ADDENDUM NO. 2

PROJECT: **BCSC - New Elementary School #12 - Maple Grove**
Tipton Lakes Blvd.
Columbus, IN 47201

ARCHITECT: **CSO Architects**
8831 Keystone Crossing
Indianapolis, IN 46240

This Addendum is incorporated with the Contract Documents for this Project and contains clarifications and revisions to the Contract Documents.

5 A430 **ENLARGED PLAN DETAIL**
SCALE: 1 1/2" = 1'-0"

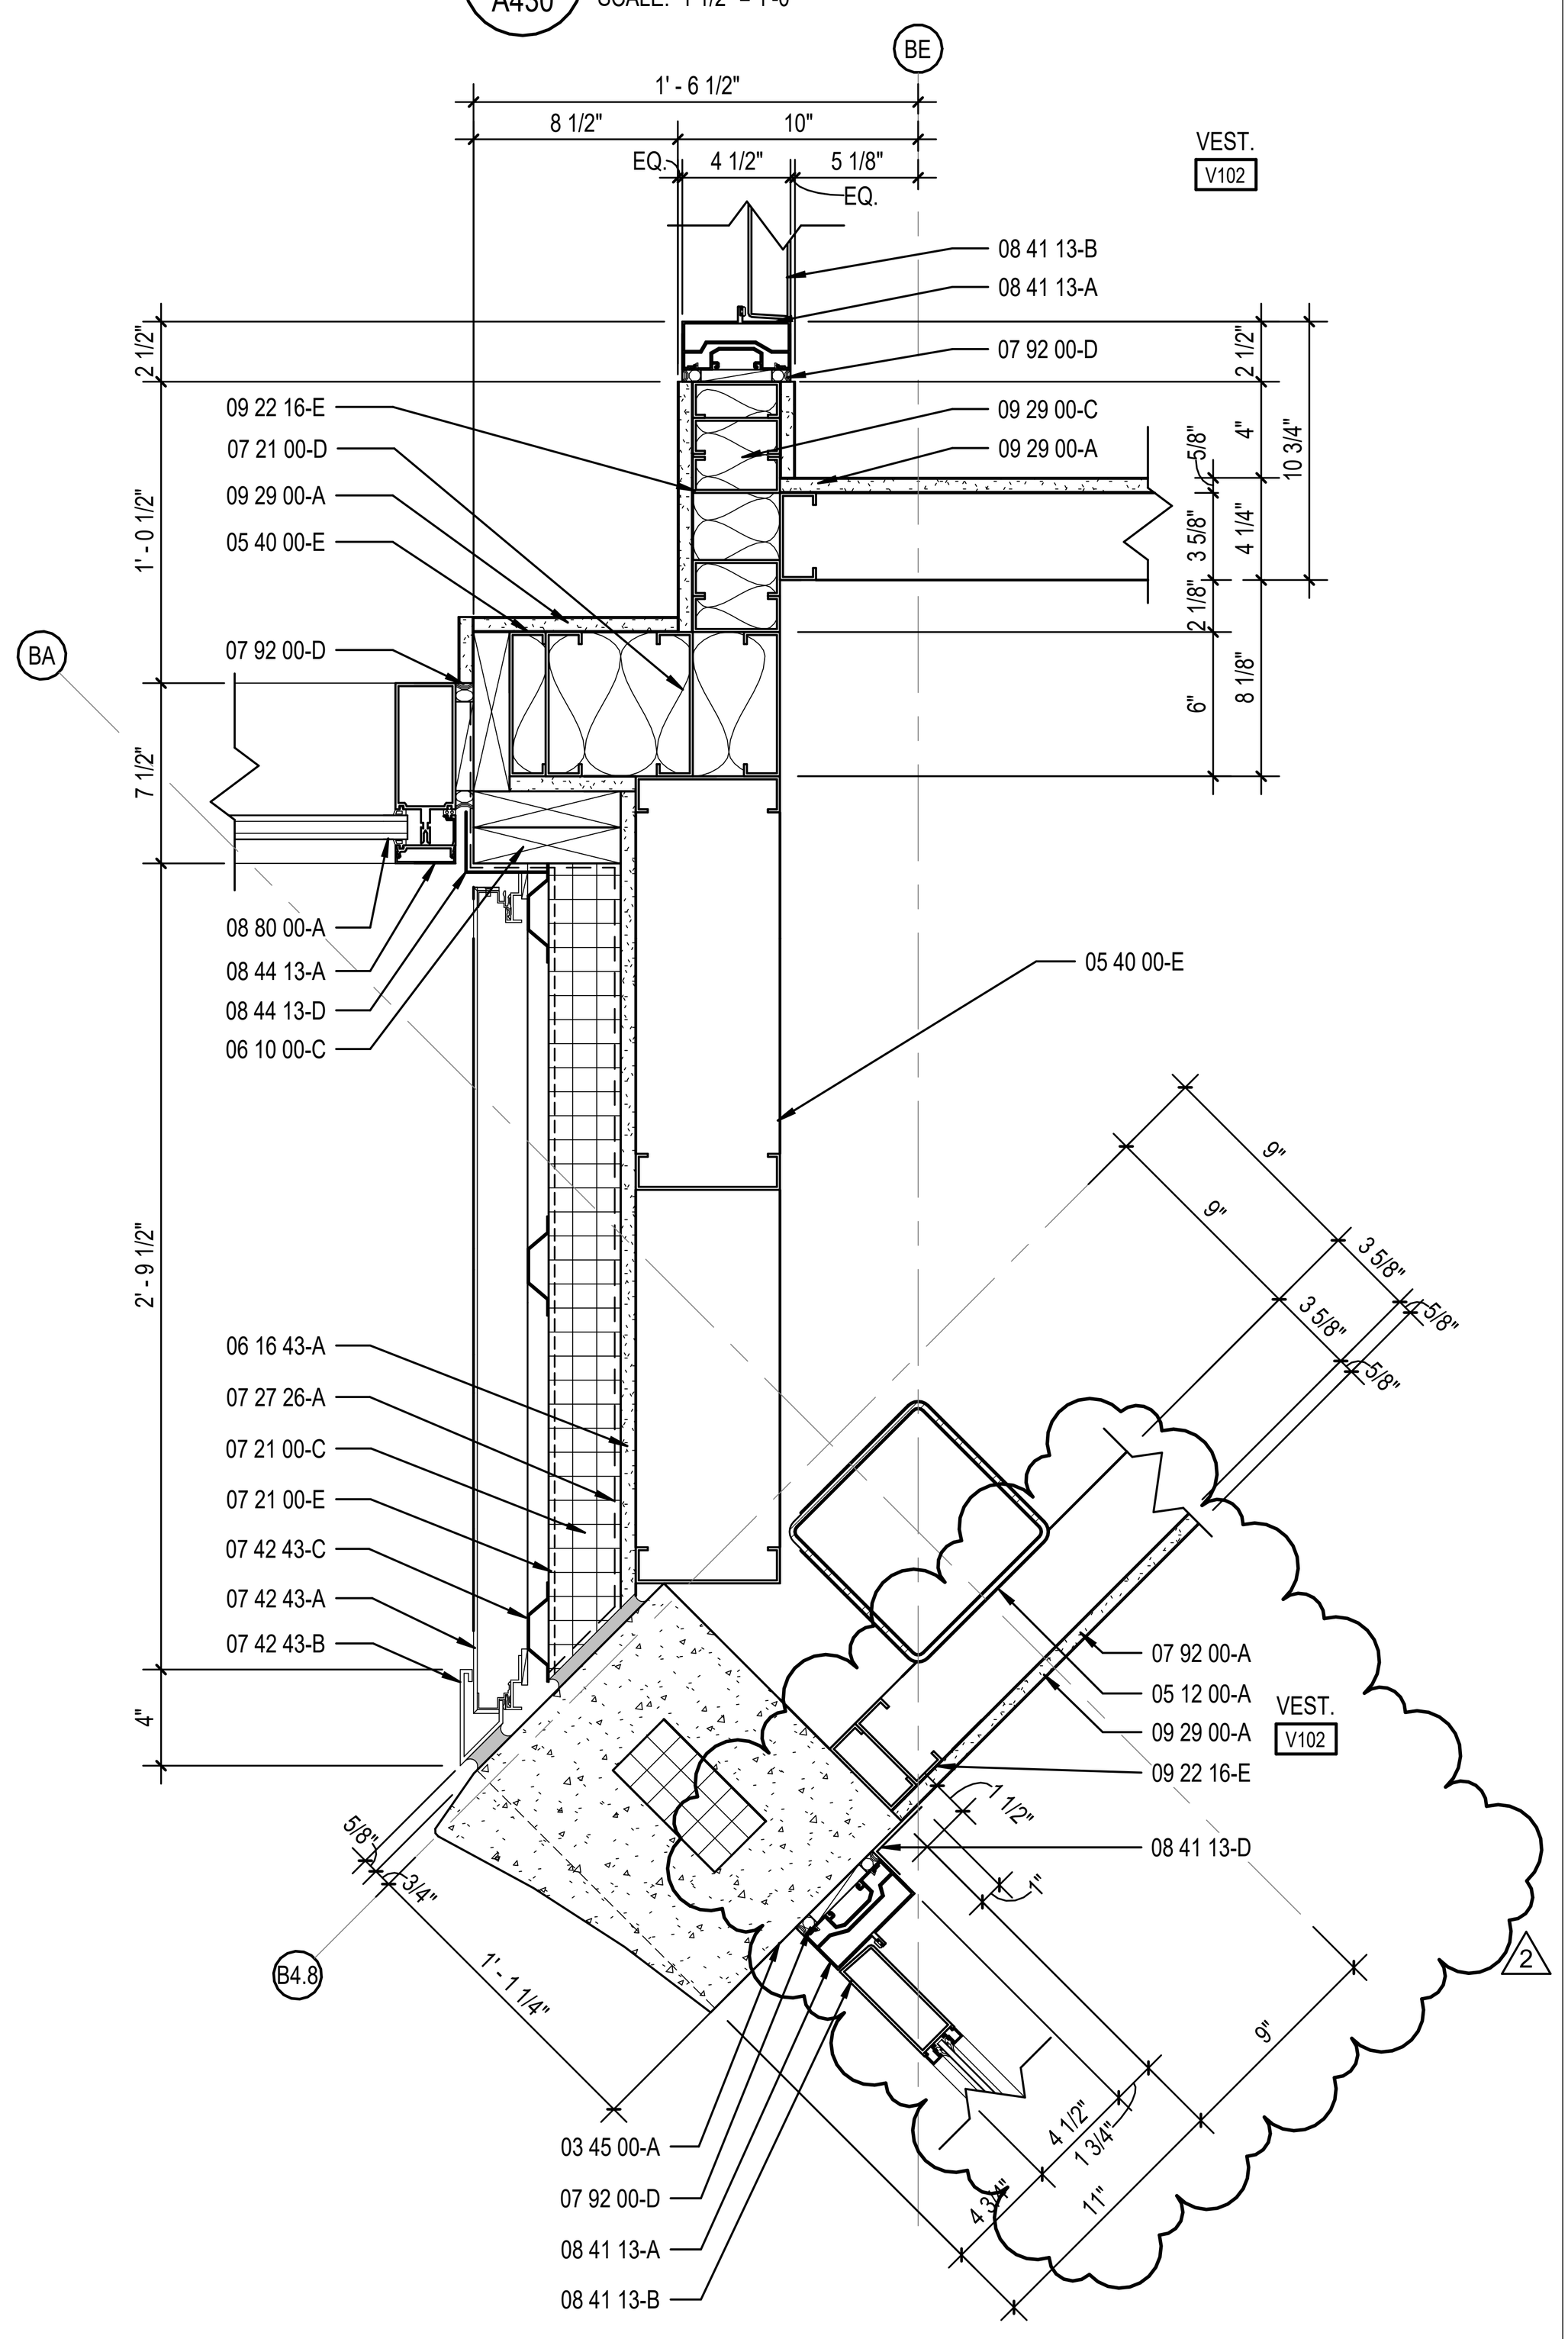
A. Detail 5/A430 ENLARGED PLAN DETAIL revise keynotes and detail as clouded on attached sheet.

5
A431
ENLARGED PLAN DETAIL
SCALE: 1 1/2" = 1'-0"

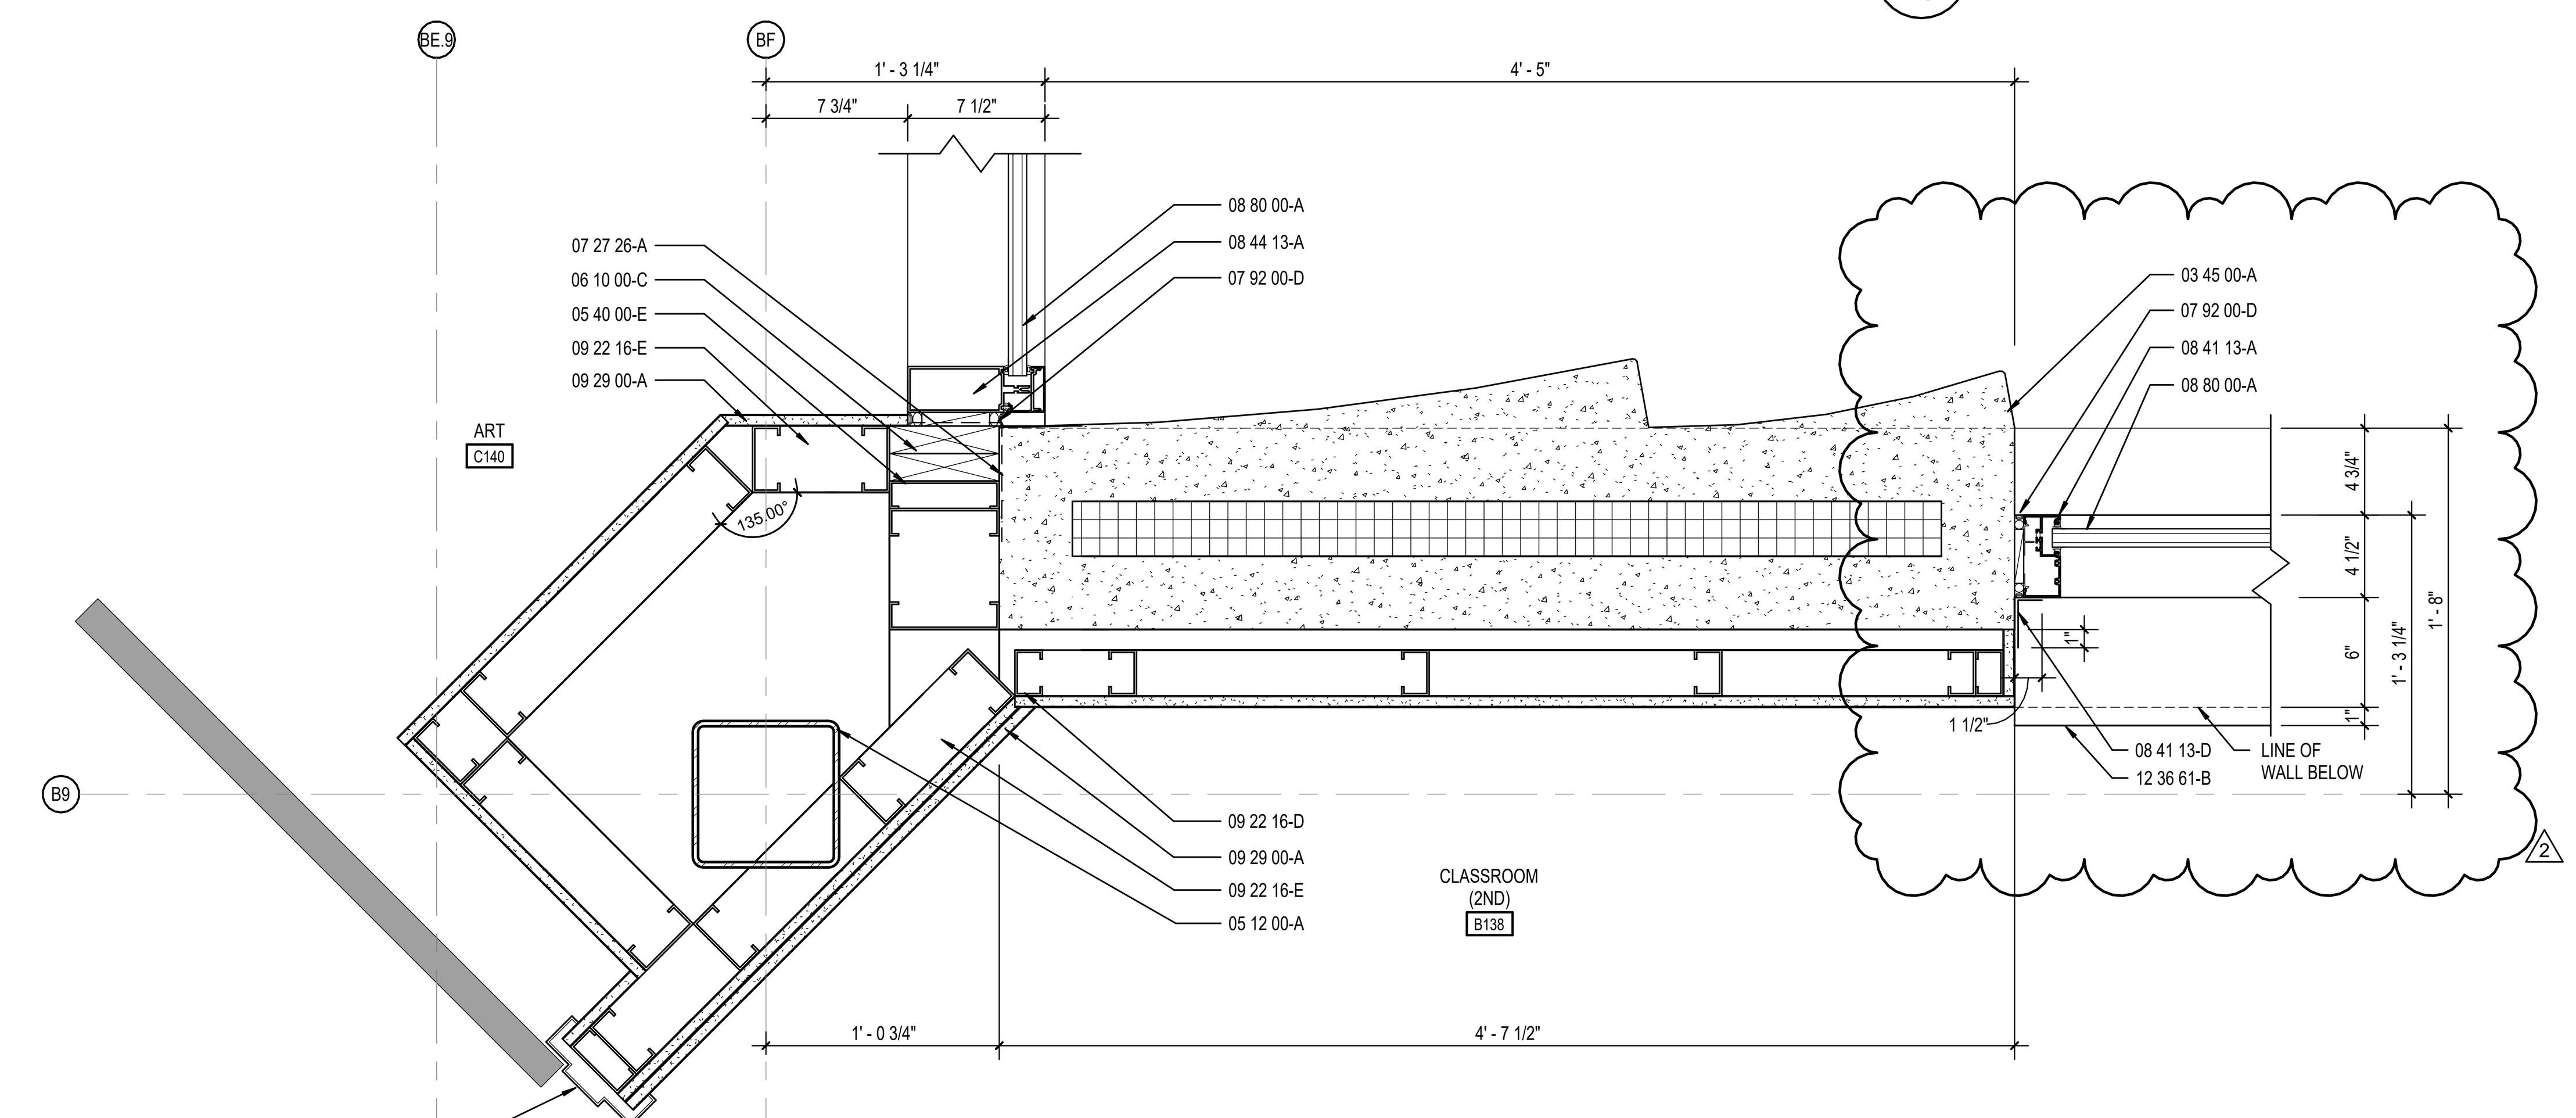
D. Detail 5/A431 ENLARGED PLAN DETAIL revise keynotes and detail as clouded on attached sheet.
